APPENDIX B

This Appendix reviews the technical calculations provided by Inmarsat and shows that the overly pessimistic assumptions used in the preparation of their supporting material is overly conservative and thus leads to a gross over-estimation of the interference possibility from the ancillary terrestrial component (ATC) of MSS systems.

**Figure 3.1-1 – Inmarsat-4 Beams with 41 dBi Gain
(Assuming ITU-R S.672-3, L_n=-20dB pattern;
contours are -3, -10, -20, -25 and -30 dB)**

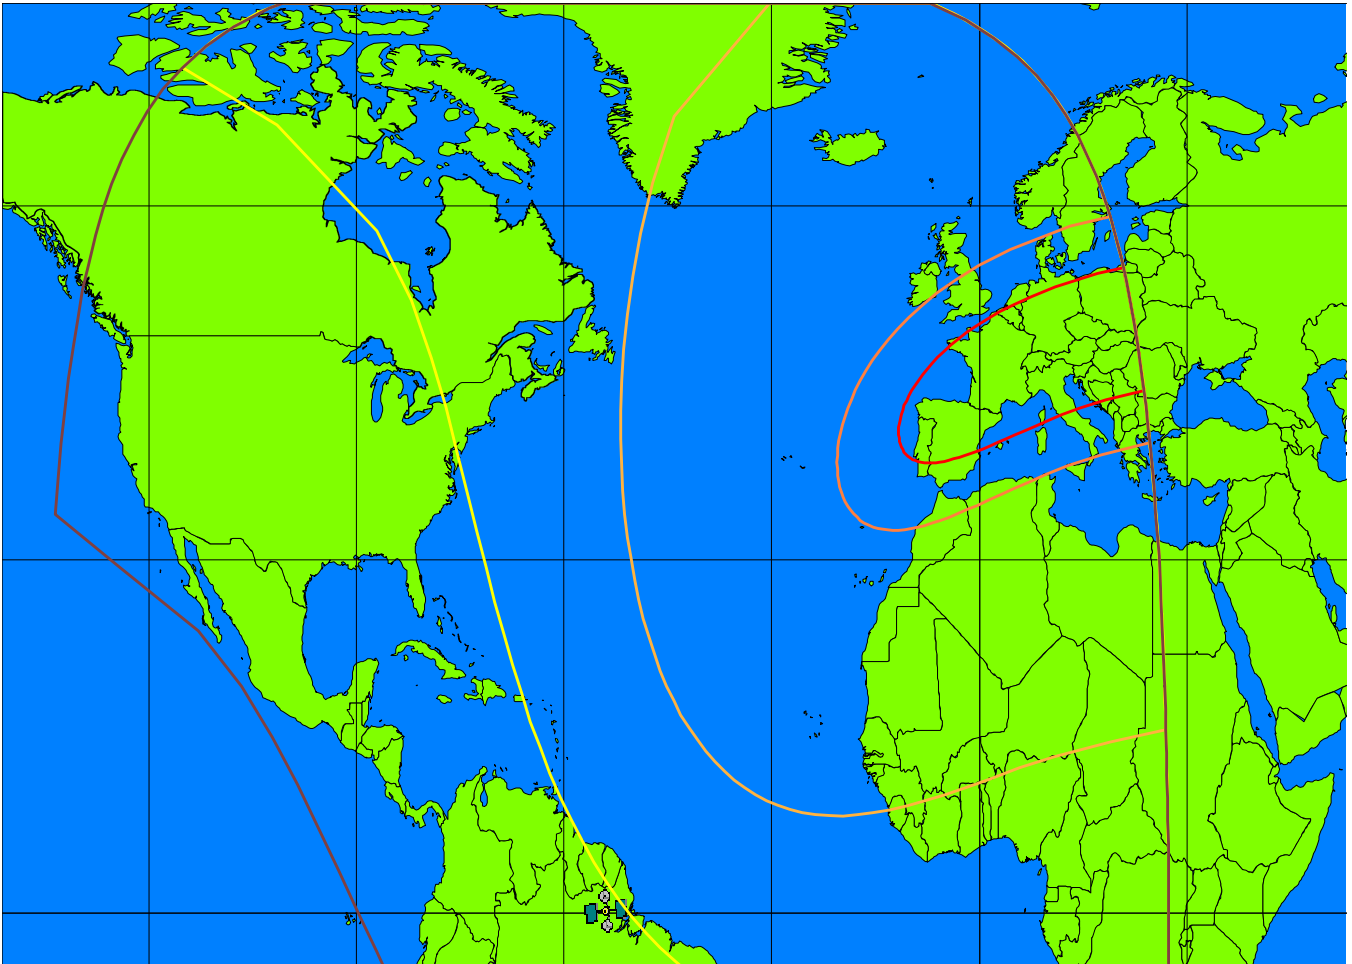
In their calculations, Inmarsat assumed only 20dB satellite antenna discrimination for their satellite antenna sidelobes for beams operating well outside North America. As for the shielding effects, such a number might be reasonable when considering a single MET transmitter located in the worst sidelobe of the Inmarsat-4 satellite receive beam. However, when considering very large numbers of MET transmitters scattered across the country, such an assumption is not reasonable. The beam contours were generated using commercially available software to represent an Inmarsat-4 receive beam centered over Western Europe and having a peak gain of 41 dBi. Figure 3.1-1 shows the contours for this beam, corresponding to an Inmarsat-4 satellite located at 54°W. This figure shows that while the -20 dB contour reaches North America, the gain of the antenna pattern quickly drops below 25 dB over a very large portion of Canada. It should also be noted that the most pessimistic ITU-R satellite antenna pattern (Recommendation ITU-R S.672-3, Ln=-20dB) was used for this graph. While some very small portions of eastern Canada will “hit” the satellite at the -20dB level, the average gain is better than 25 dB below peak gain.

**Figure 3.1-2 – Inmarsat-4 Beams with 41 dBi Gain
(Assuming ITU-R S.672-3, L_n=-30dB pattern;
contours are -3, -10, -20, -25 and -30 dB)**

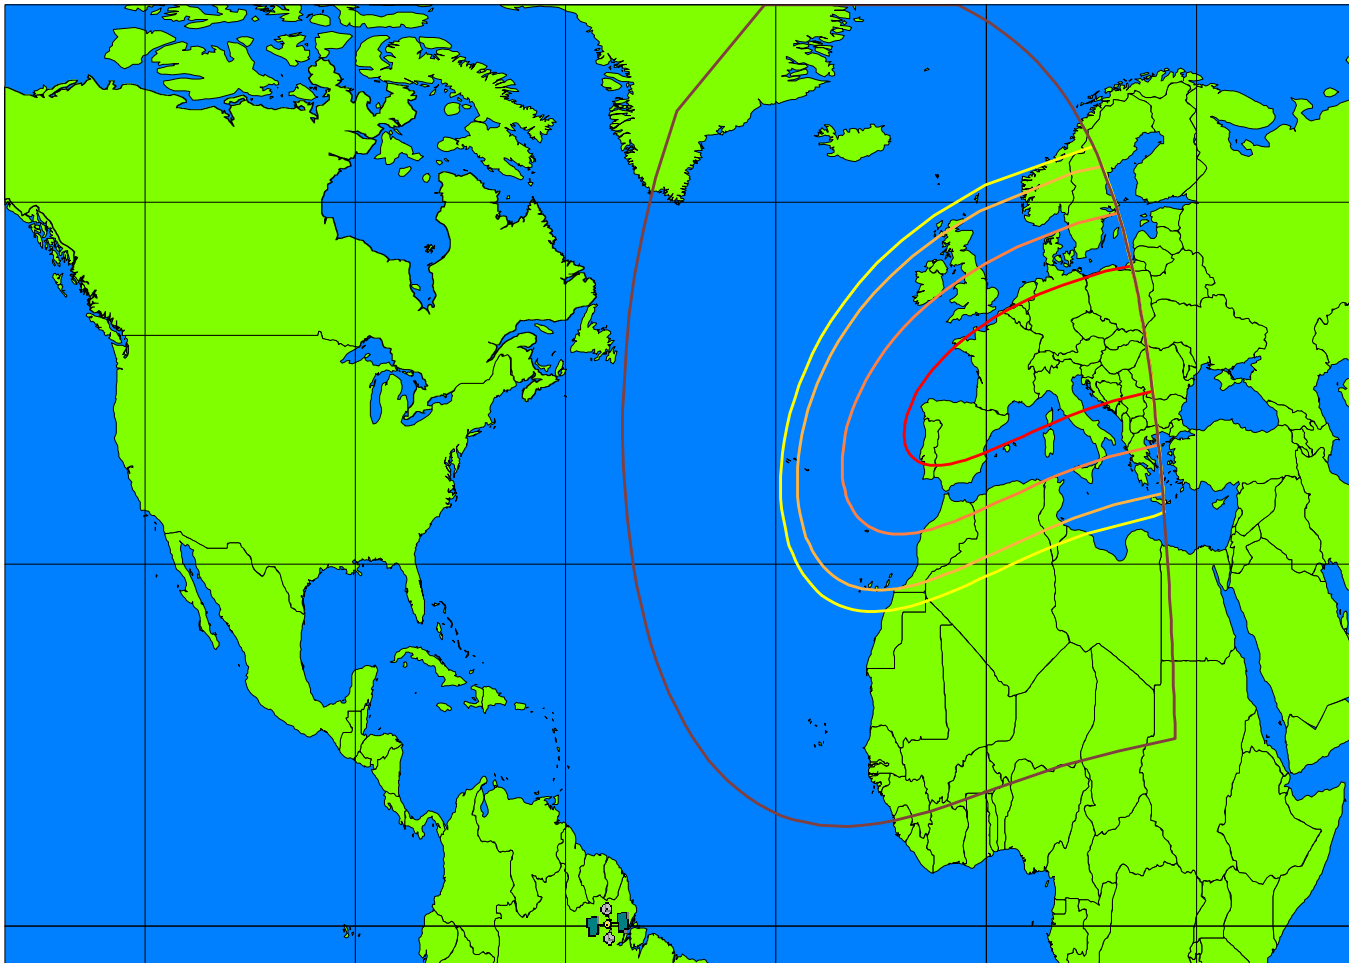
If we were to consider a better antenna pattern for the Inmarsat-4 satellite, such as Recommendation ITU-R S.672-3, L_n=-30dB, as shown in Figure 3.1-2 below, the average gain to Canadian cities would be 30dB below the peak gain. This would improve the interference calculation results by another 5 dB (or a reduction of 3 in $\Delta T/T$).

Figure 3.3-1 Antenna Patterns for Base Stations with 16 dBi Gain Based on Two Models of Recommendation ITU-R F.1336

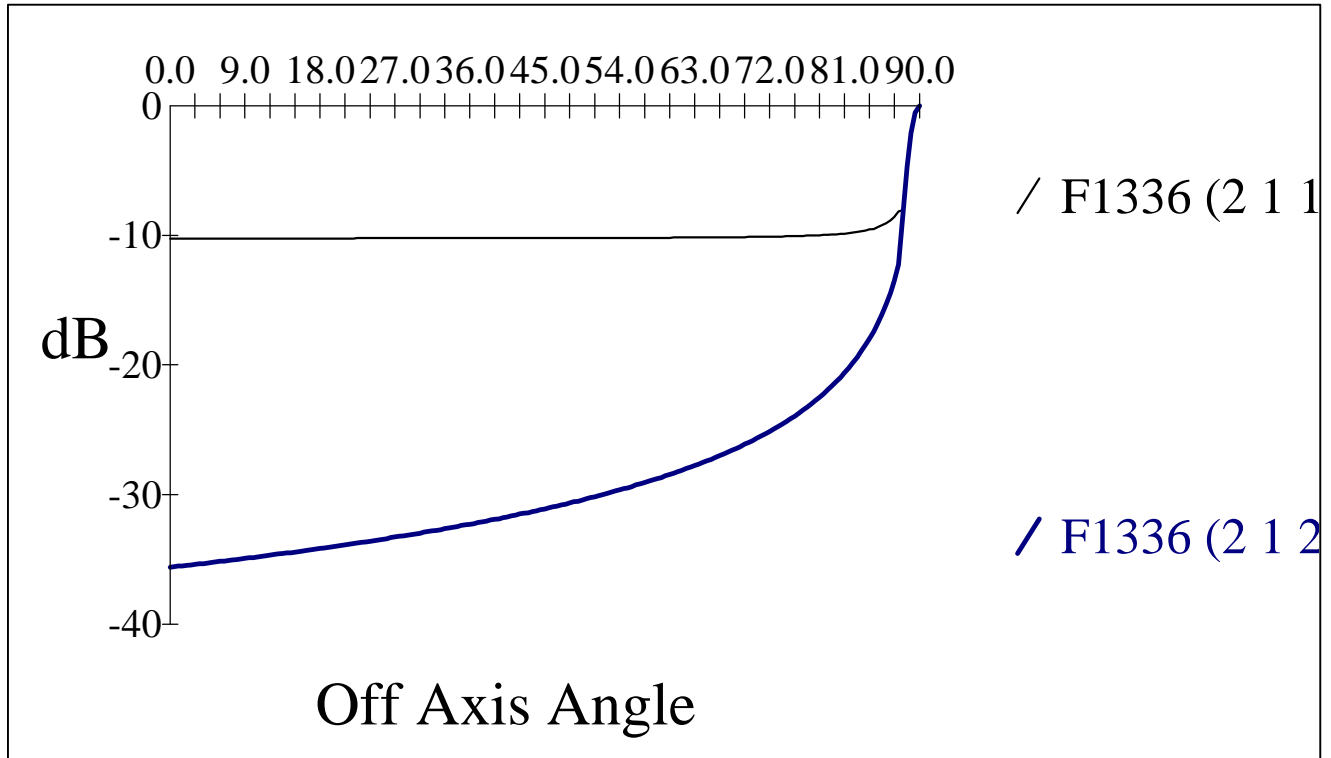
Figure 3.3.1 provides the antenna pattern, in terms of relative gains, for the two models described in the recommendation. In the figure below, the 90 degrees mark represents the direction of maximum gain (in the case of the -5° tilt angle this would be shown as 90° on the abscissa), while 0° represents Zenith.

This figure clearly shows that ITU-R recommended antenna patterns with improved sidelobes provide much better isolation than the model assumed by Inmarsat. There is another compelling reason not to use the model provided in *recommends 2.1.1*. Since the maximum gain of the antenna is 16 dBi, the first model would result in gains over all directions greater than 6 dBi, since the maximum discrimination is only 10 dB. It is not physically possible to construct an antenna that has positive gain in all directions. Using this model for the antenna described by MSV will necessarily result in unrealistically high levels of interference.

Based on these observations, it is our opinion that the base station antenna can meet the specifications supplied by MSV which are similar to the model proposed in Recommendation ITU-R F.1336 (*recommends 2.1.2*).

**Figure 3.4-1 Possible Spectrum Reuse Approach
Showing Additional Discrimination to Other MSS Systems**

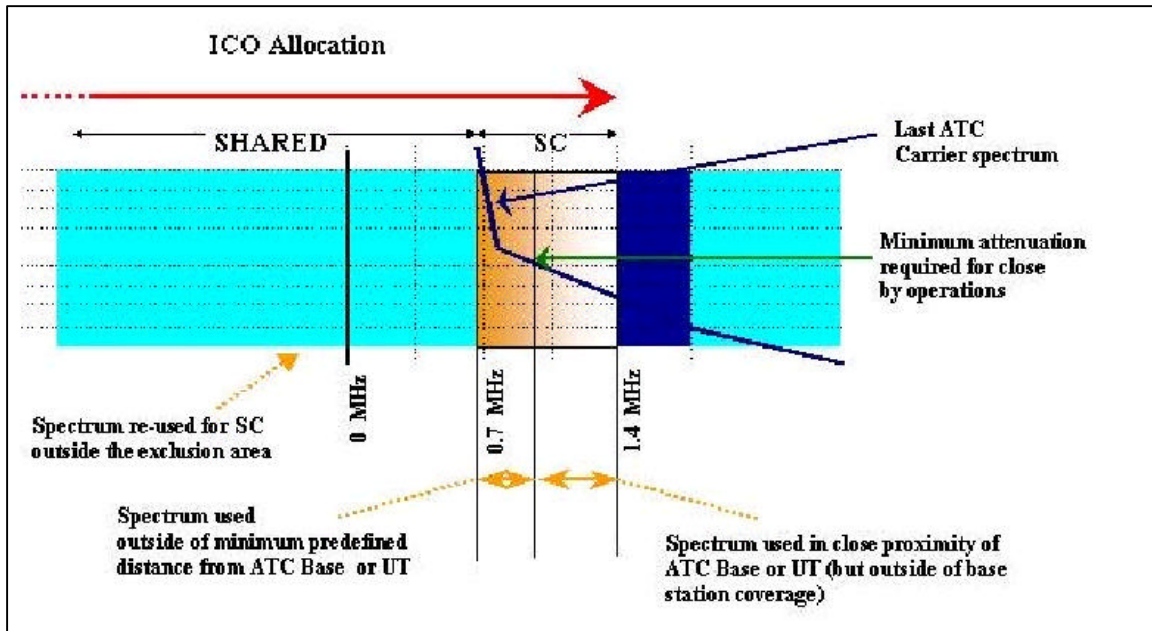
For this interference mode, the critical issue is the out-of-band (OOB) rejection capability of the ATC BS signals. The OOB specification used by Inmarsat in its studies is the minimum mandated by the FCC. It is a well-known fact that systems can be designed to significantly improve on this specification. Inmarsat results show an interfering signal which is 38 dB above the Inmarsat MET receiver noise. If these assumed parameters were to be used, the ATC BS transmissions would also interfere into adjacent carriers of the MSV satellite network. In order to control self-interference, the ATC BS transmissions will need to improve on the FCC specification. In fact, ICO believes that it would be possible to provide much more isolation for OOB attenuation into other MSS operators' usable band¹⁴. Figure 3.4-1 shows the concept of using additional guard bands to protect adjacent licensees operations. As can be seen from this figure, it is possible to allocate more sensitive MSS downlink carriers (those that are operated closest to the base station) further away from the ATC band. Additional guard bands can be provided to protect adjacent MSS systems.
